Agreement No. CE 36/94
Reclamation and Servicing of
Tuen Mun Area 38 for Special
Industries - Improvement to
Roads and Junctions within Tuen
Mun Environmental Impact
Assessment :
*Environmental Impact Assessment
Report*

Agreement No. CE 36/94
Reclamation and Servicing of Tuen Mun Area 38 for Special Industries -
Improvement to Roads and Junctions within Tuen Mun
Environmental Impact Assessment Report
Final Report

ADDENDUM

FIGURE 1.1a - ENVIRONMENTAL IMPACT ASSESSMENT STUDY AREA

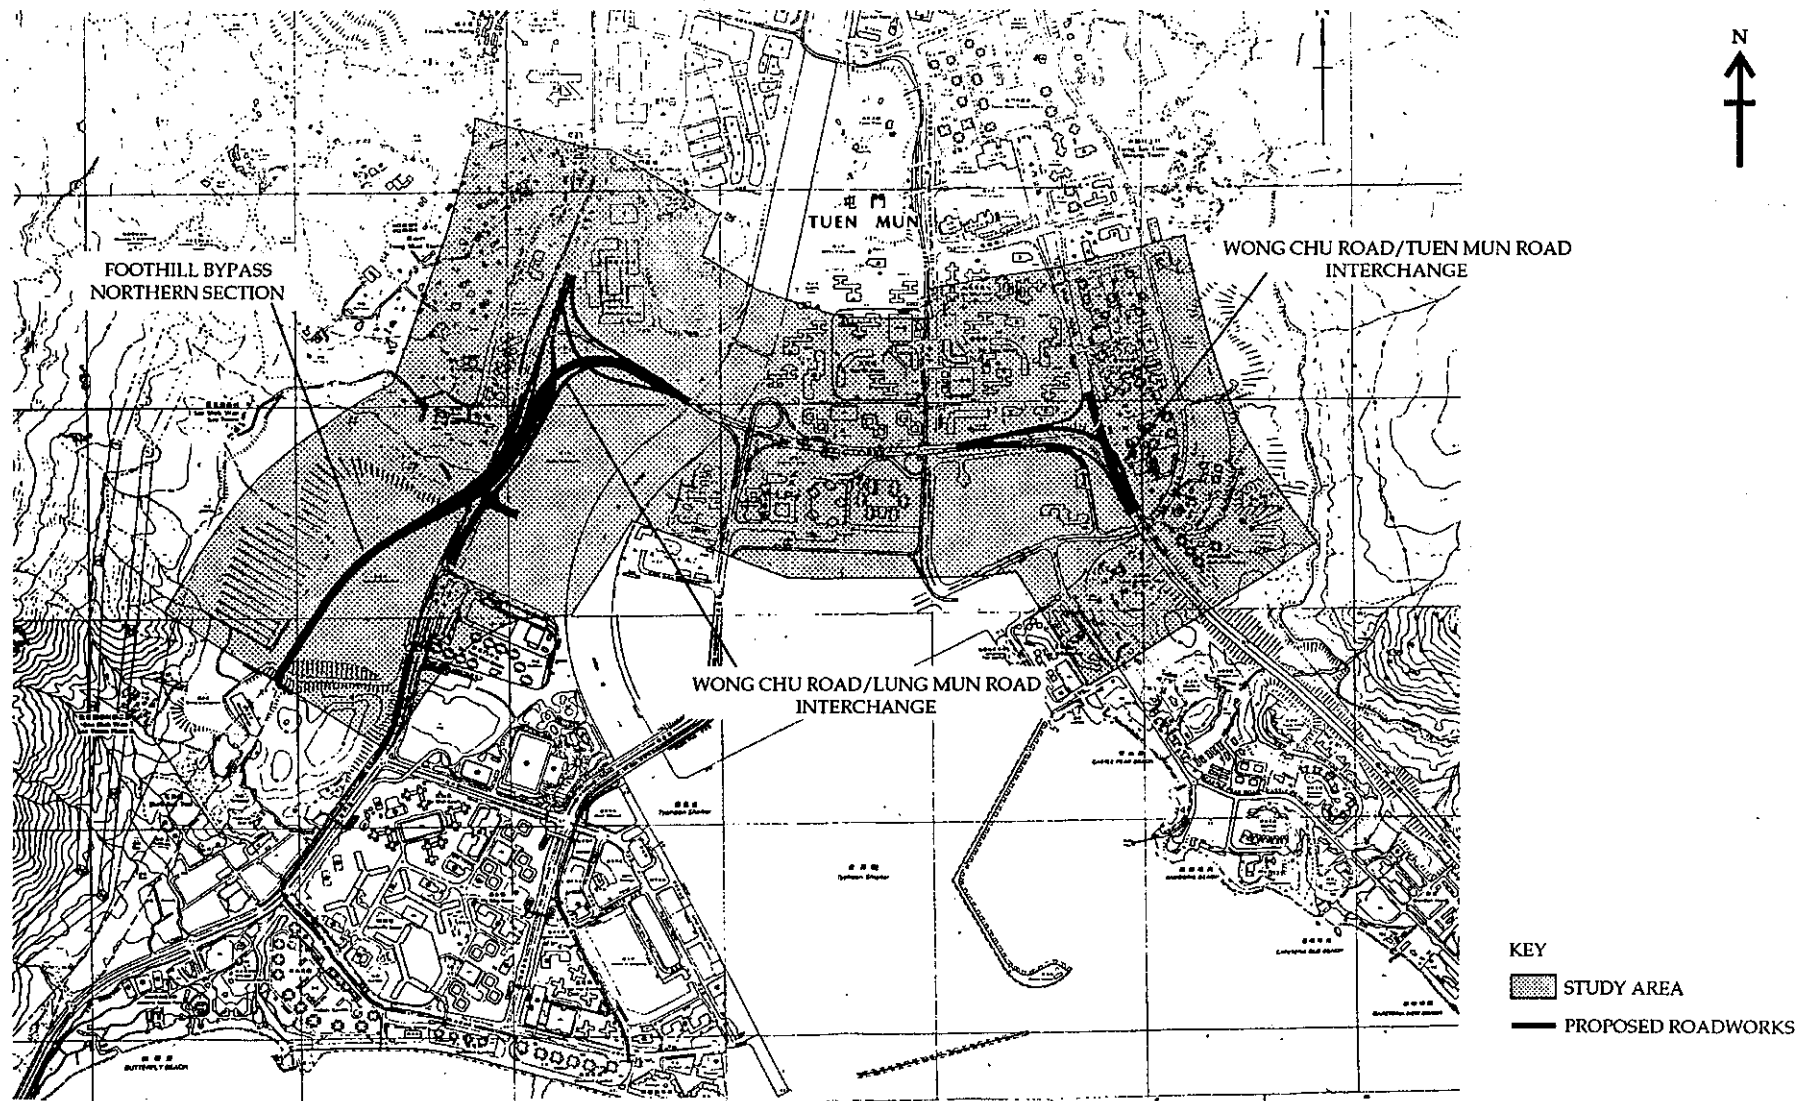
53			<p><i>Noise Impact – General</i></p> <p>(a) The Study Area and the proposed roadwork for the Lung Mun Road Bypass as shown on Figure 1.1a extend beyond those indicated in Figure 2.1b and the noise model. The Consultants should clarify.</p> <p><i>Construction Noise Impact</i></p> <p>(b) Section 3.2.2</p> <p>The Consultant should note that percussive piling is controlled all day and a CNP is required for such works.</p>	<p>As indicated in Section 2.1, scheme plans used for Figures 2.1a & 2.1b were provided by HyD and there is no details on the Foothill Bypass Northern Section apart from the alignment shown in Figure 1.1a.</p> <p>Noted, text amended.</p>

No.	Department	Reference	Comments	Consultants' Response
83			<p><i>Noise Impact</i></p> <p><i>Figure 1.1a</i></p> <p>At the western end of the roadworks (ie the Foothill Bypass), the Study Area as shown on Figure 1.1a terminates at the end of the roadworks. ERM should note that the Study Area, for the purpose of the noise impact assessment, should at least cover an additional 300m after the termination of the roadworks. Figure 1.1a should be amended accordingly.</p>	The noise assessment was based on the Study Area defined in the Study Brief.
84			<p><i>Section 2.6 Noise Barriers and Enclosures, 4th paragraph</i></p> <p>ERM should justify in the report why full fire fighting services cannot be provided for a full enclosure longer than 230m. Secondly, the phrase "of a minimum total floor area of 6.25%" would be better rephrased to "with an open area equal to or exceeding 6.25% of the road surface area".</p>	See response no. 6.

FIGURE 5.2a - LOCATIONS OF NSRs AND 'NEW' ROADS

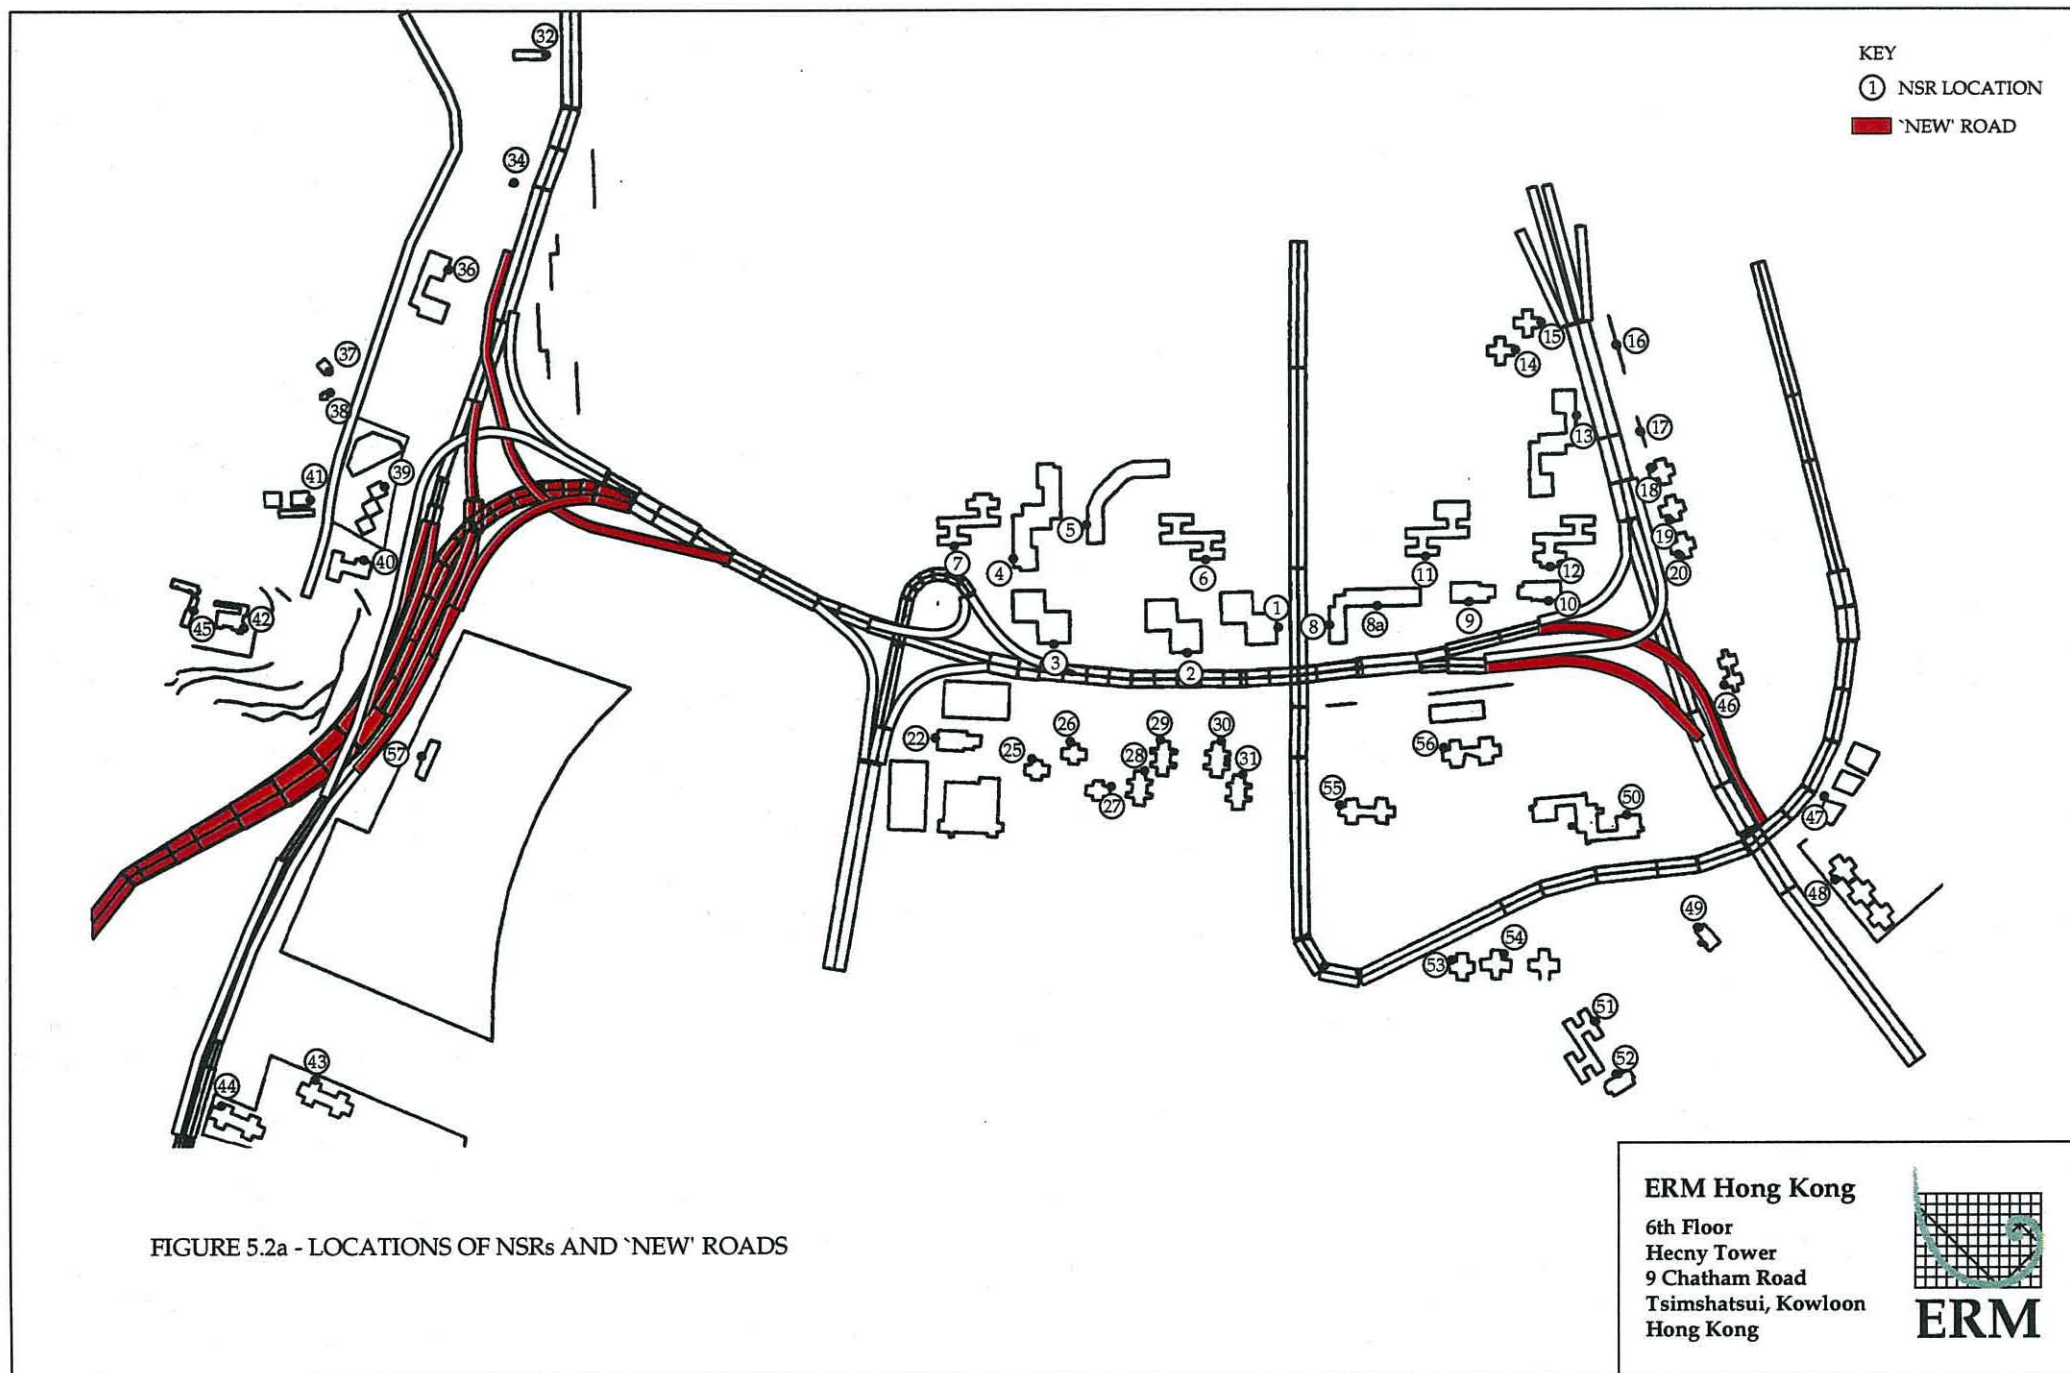
No.	Department	Reference	Comments	Consultants' Response
18			(g) Figure 5.2a mentioned in Section 5.2 is not enclosed within the report.	The figure will be included in the Final Report.
19			(h) Referring to Section 5.5, just the 5m high barrier along the southbound section of the Foothill Bypass is adequate to contain the noise impact. The 5m cantilever barrier shown in Figure 5.5b and Figure 5.5c for this section of the Bypass should be amended to be consistent with the text.	Agreed. The figures will be amended accordingly.
20	Highways Dept (SLA)	HYDT 12/6/44	<p>(a) General Visual/Landscape Considerations</p> <p>These issues are not adequately addressed in the Report. Please note that the road scheme plus the proposed noise mitigating structure will destruct the existing roadside amenity planting which is of significant importance to provide visual buffer and dust filter to the neighbourhood. Removal of them will severely degrade the existing landscape quality and amenity value. Please therefore look into this matter in details and information such as the number of existing trees affected by the scheme, the proposed compensatory scheme to improve the landscape quality and amenity value should be provided. Please note that despite noise and air pollution addressed in the Report, visual, landscape and amenity issues are also important aspects in environmental consideration and what we are after is a comprehensive assessment on the total environment affected by the scheme.</p>	As stated in the Inception Report (para 3.2.7), visual/landscape considerations will be given to conceptual design of the mitigation structure to ensure that these structures will be aesthetically compatible with the surrounding land uses and will provide a comfort environment to pedestrians. The requested comprehensive landscape and visual impact assessment is outside the scope of this EIA study.

<p><i>Operational Traffic Noise Impact</i></p> <p>(d) Section 5.2</p> <p>Figure 5.2a is missing in the report.</p> <p>(e) Table 5.2 and Table 5.2b</p> <p>The Consultant is required to indicate the PD levels of the receiver points in the report.</p>	<p>Noted, Figure 5.2a will be included in Final Report.</p> <p>These tables will be included in the Final Report to show PD levels.</p>
